# ADDENDUM NO. 4

May 5, 2022

# YOST ELEMENTARY SCHOOL ADDITIONS AND RENOVATIONS Chesterton, IN 46304

This Addendum consists of Pages ADD 4-1 and attached Addendum No. 4 from Gibraltar Design dated May 4, 2022 and consisting of 5 pages and 24 drawings.

UNIT "E" ARCHITECTURAL FIRST FLOOR PLAN

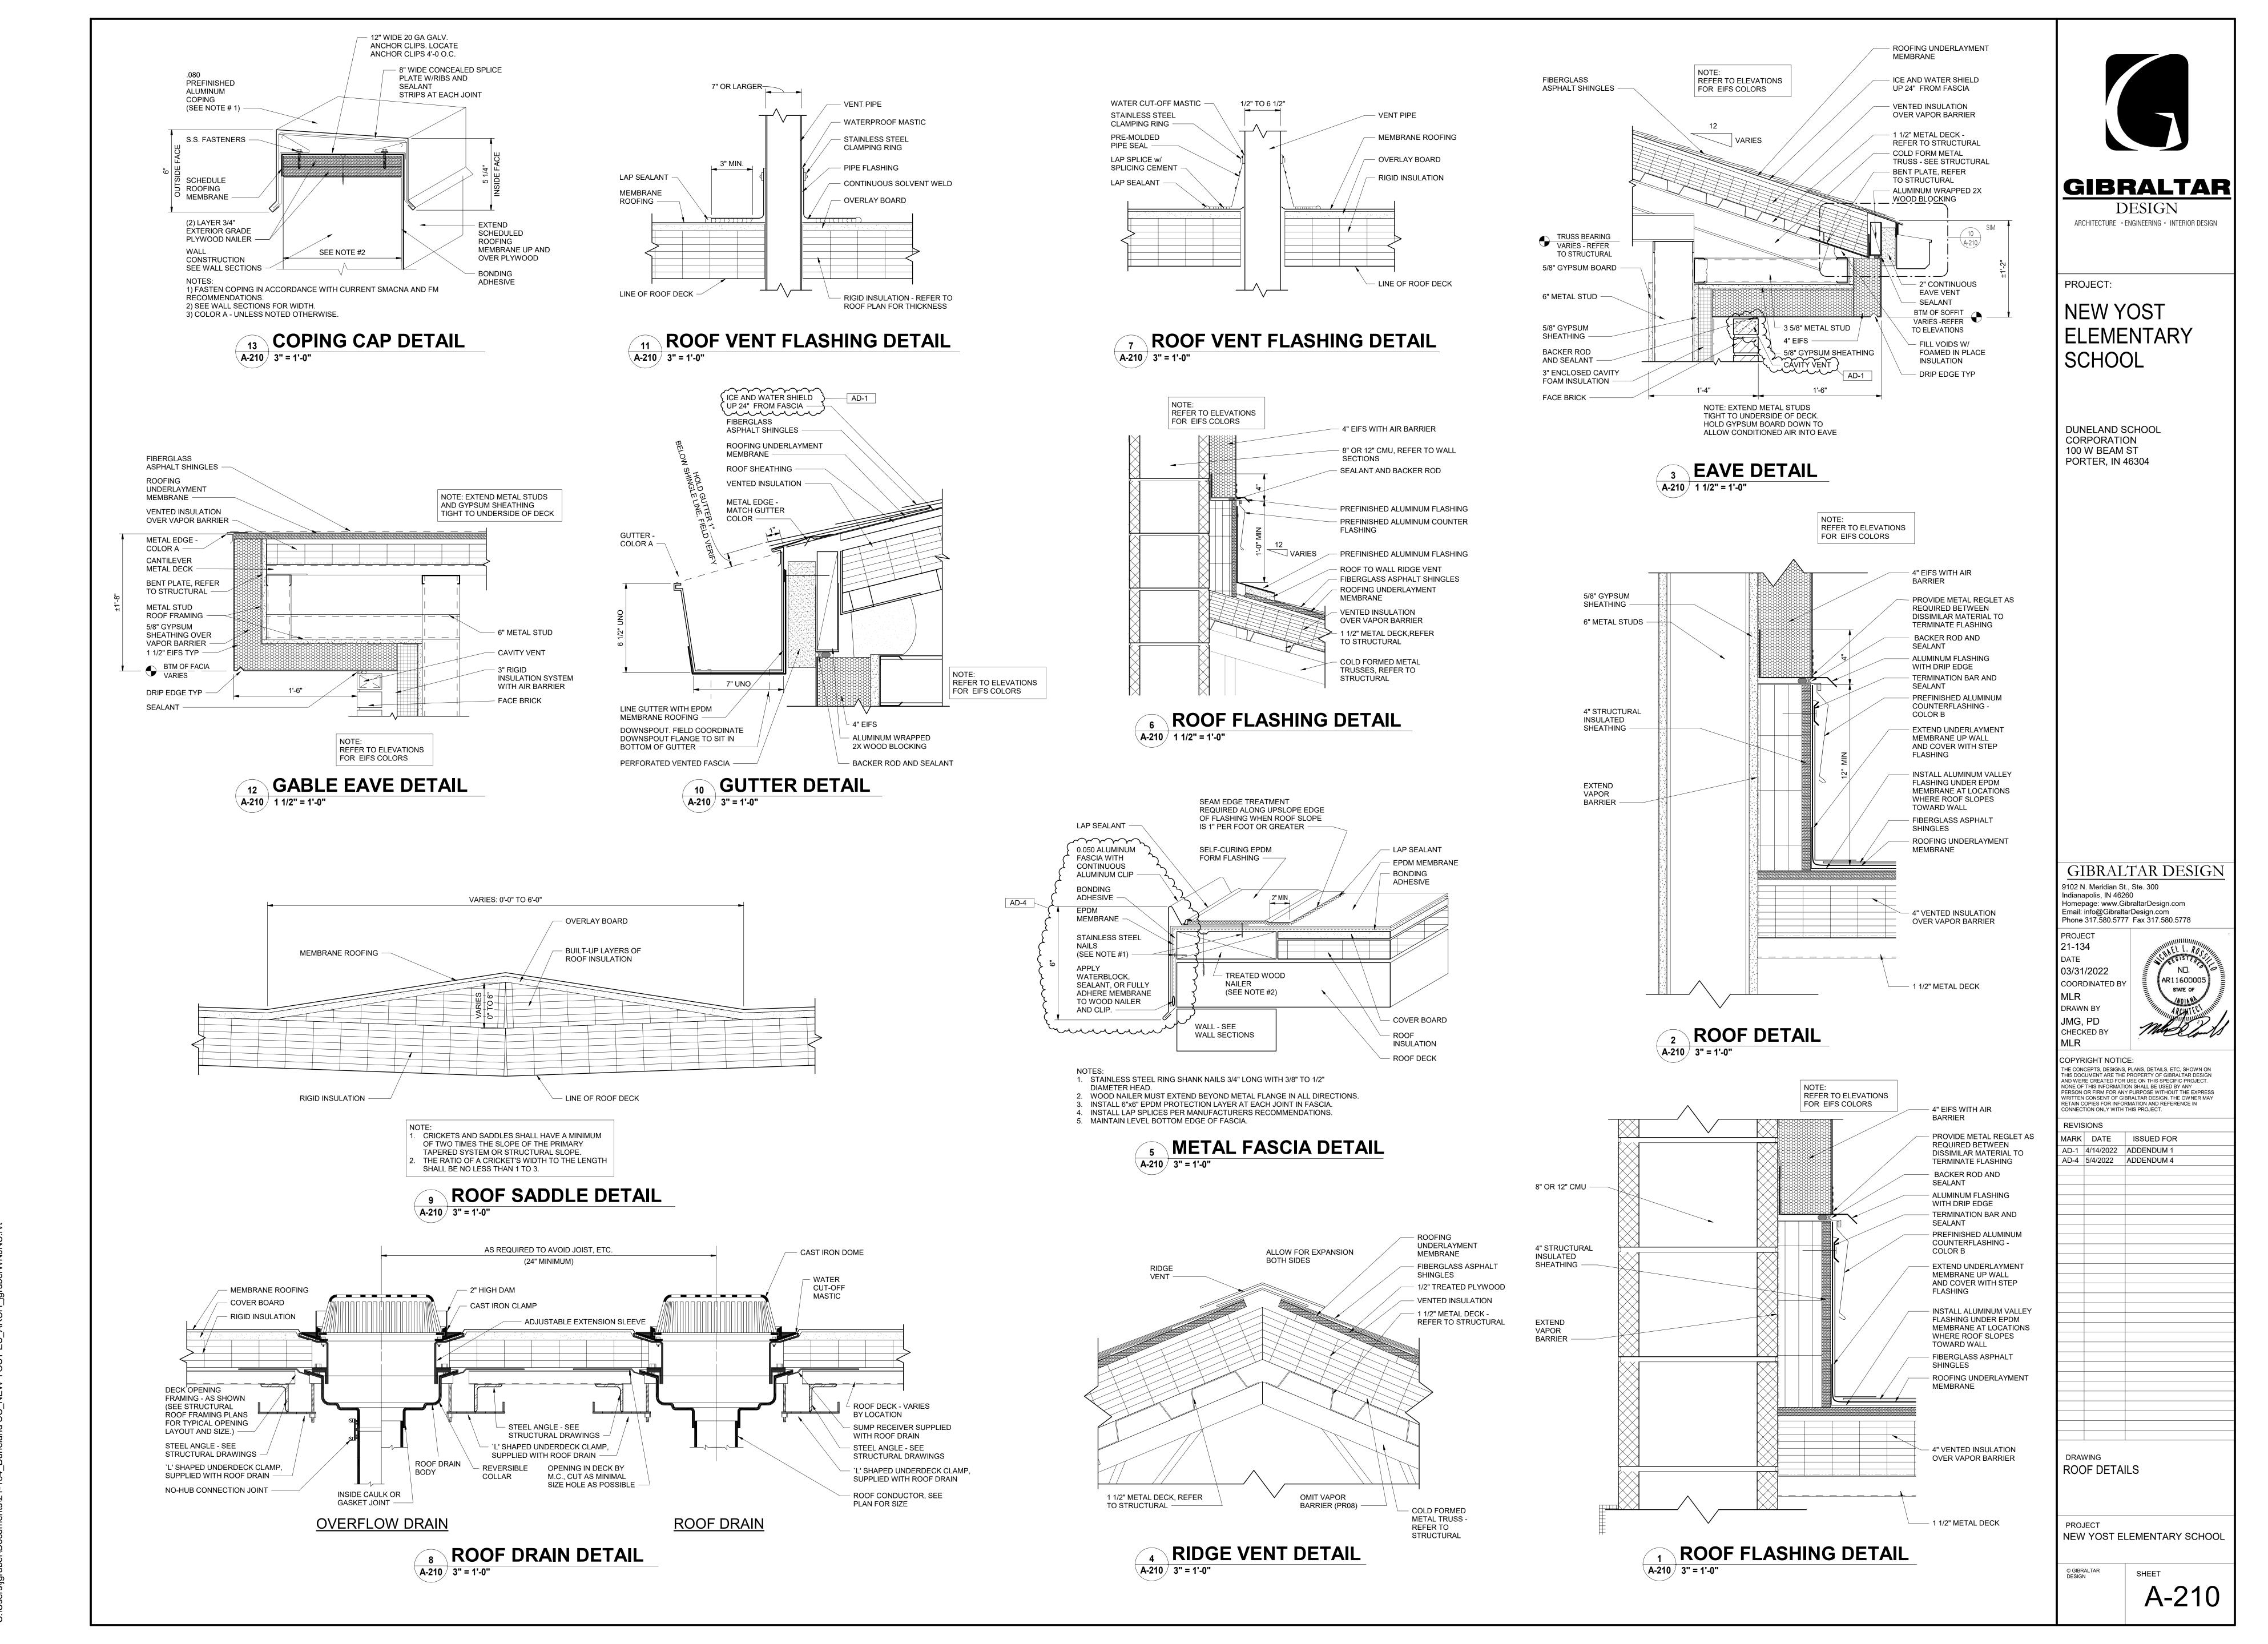
A. Refer to revised full size drawing, included in this Addendum, for clarification of partition types at Vestibule E-101.

SHEET A-211

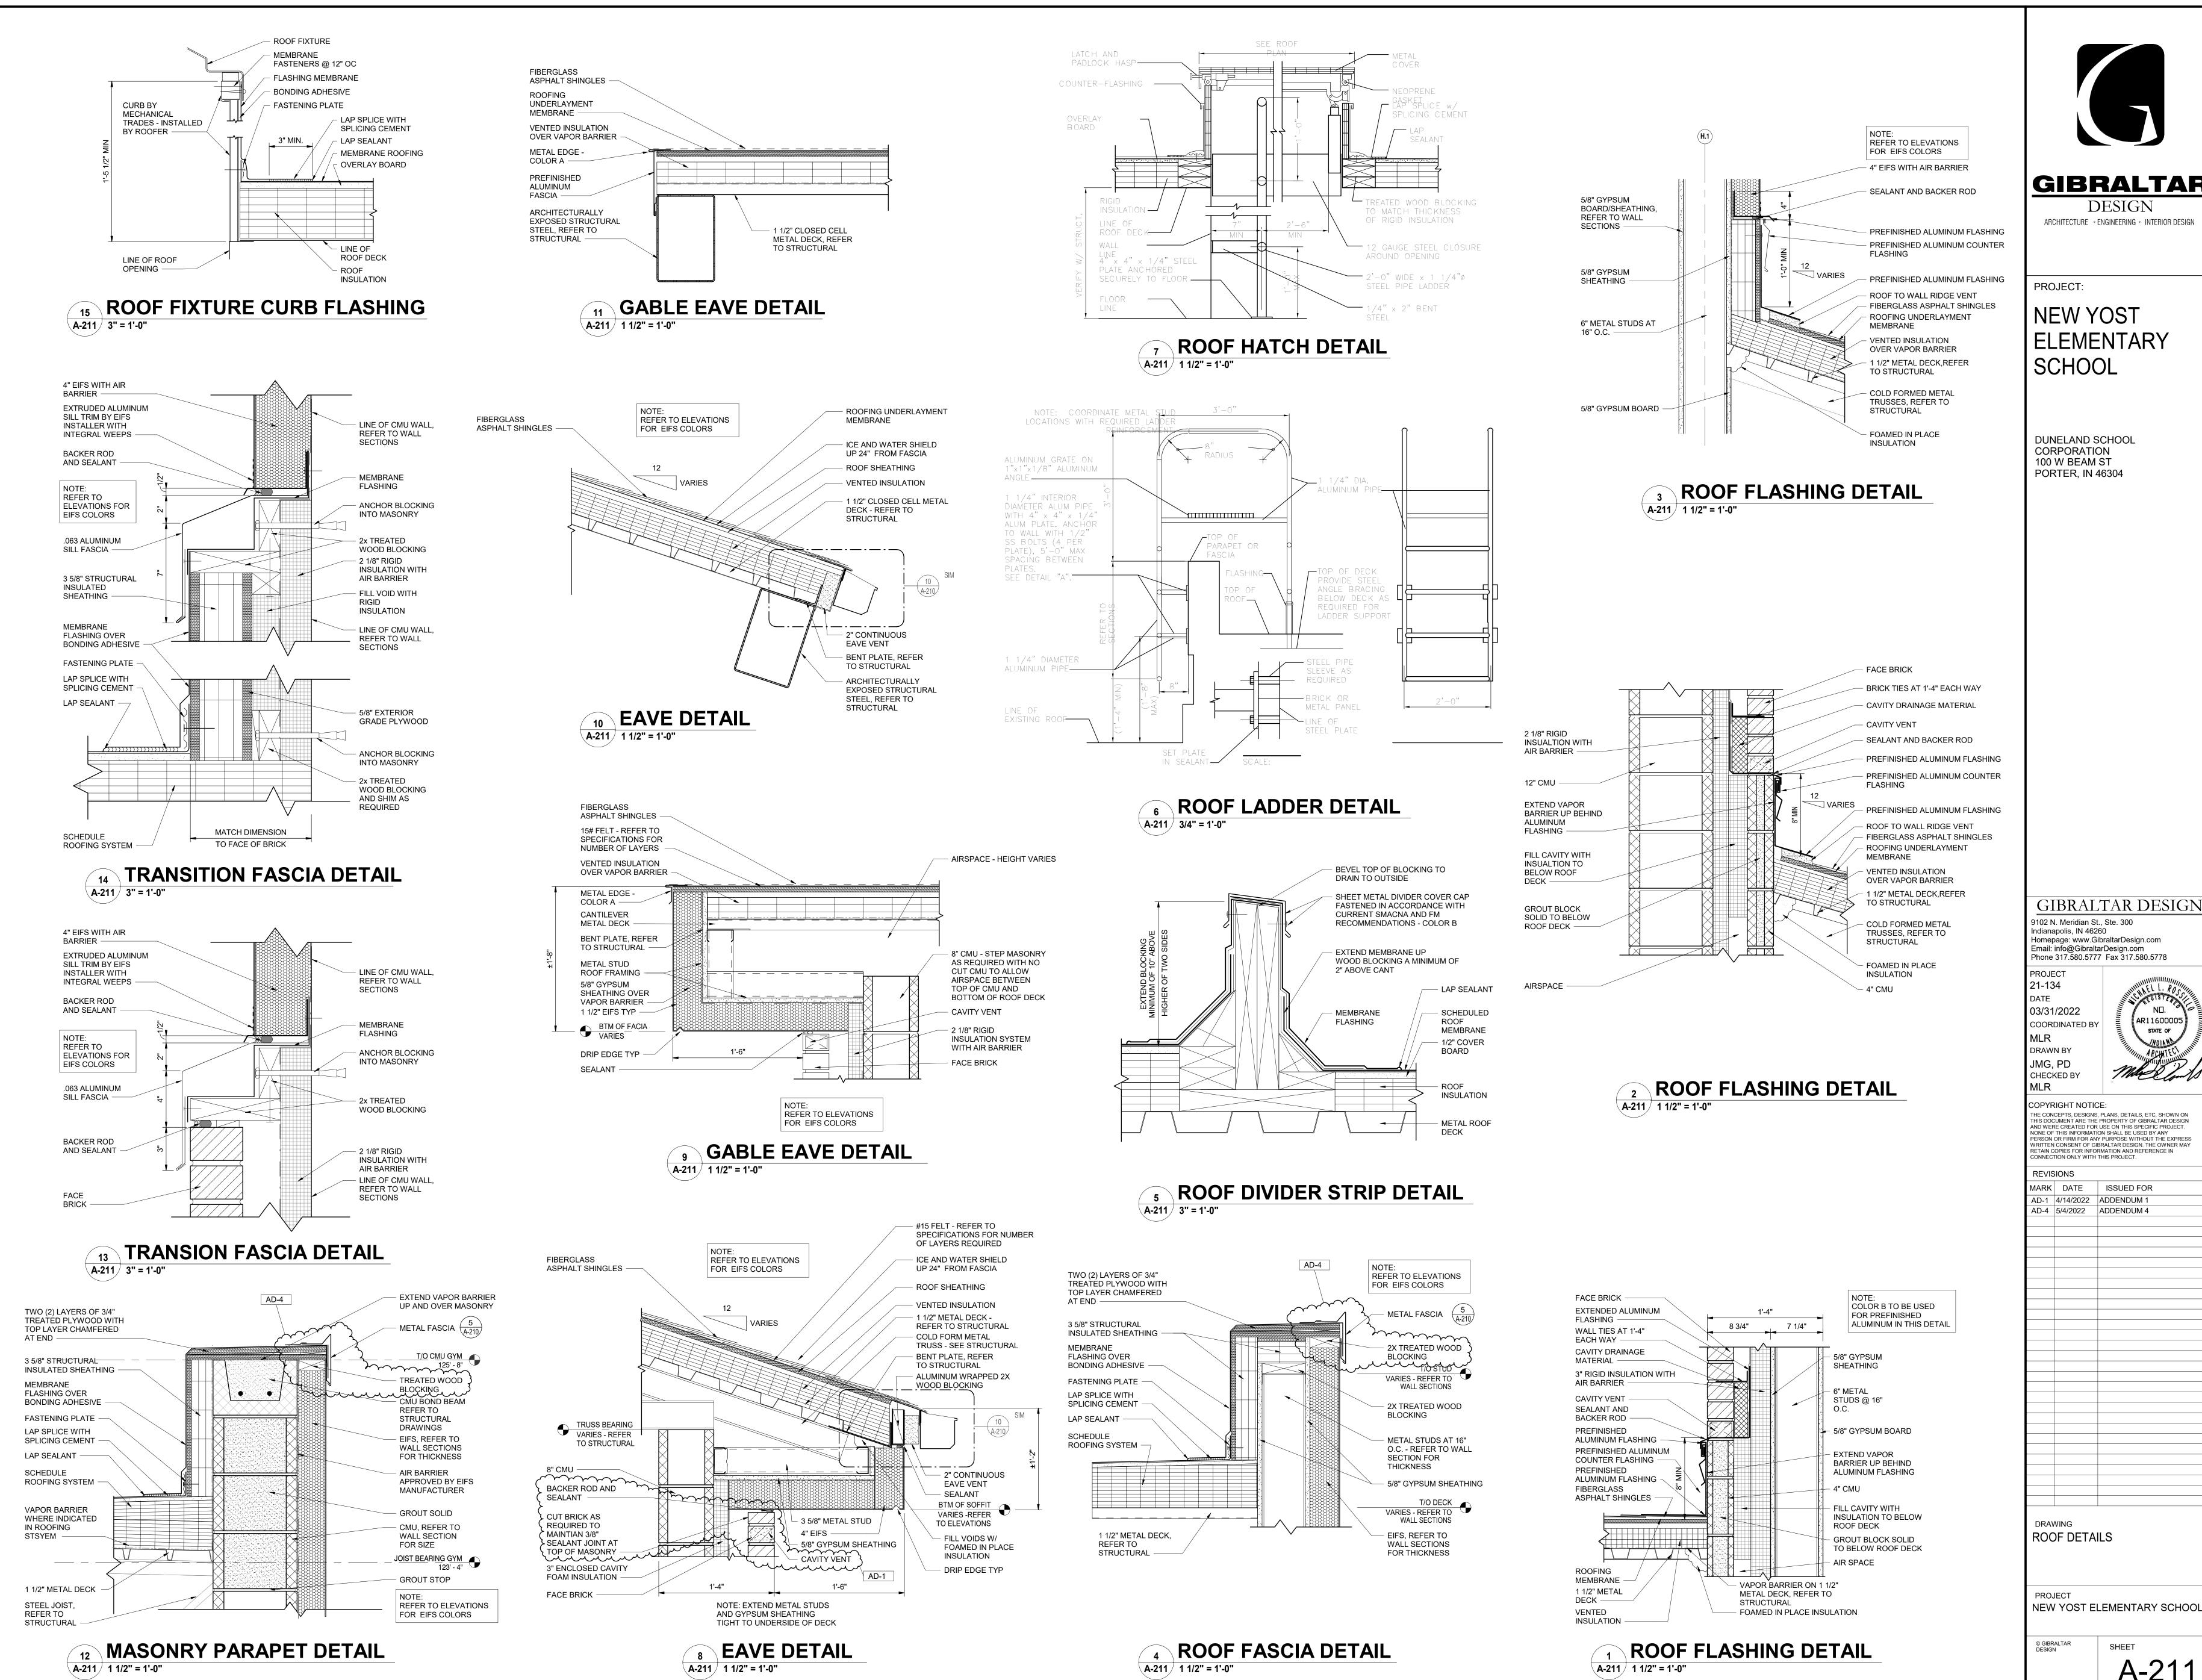
- A. Refer to revised full size drawing, included in this Addendum, for the following revisions:
  - Roof Fascia Detail 4/A-211: Change metal fascia and add treated wood blocking.
  - 2. Masonry Parapet Detail 12/A-211: Change metal fascia and add treated wood blocking.

A-830

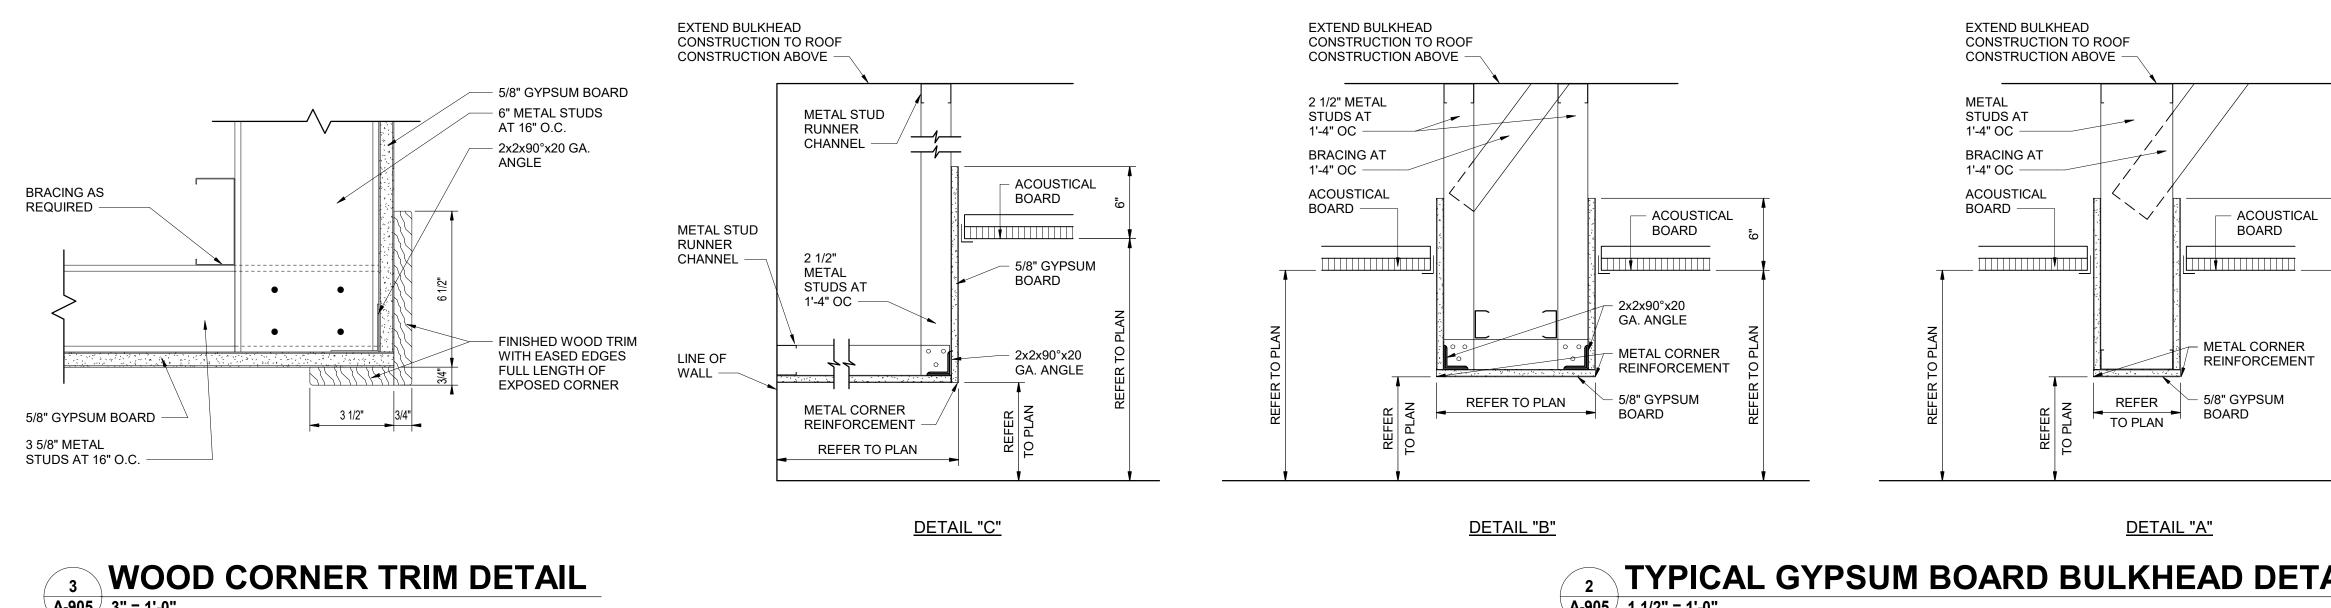
A. Refer to revised full size drawing, included in this Addendum, for the following revisions:
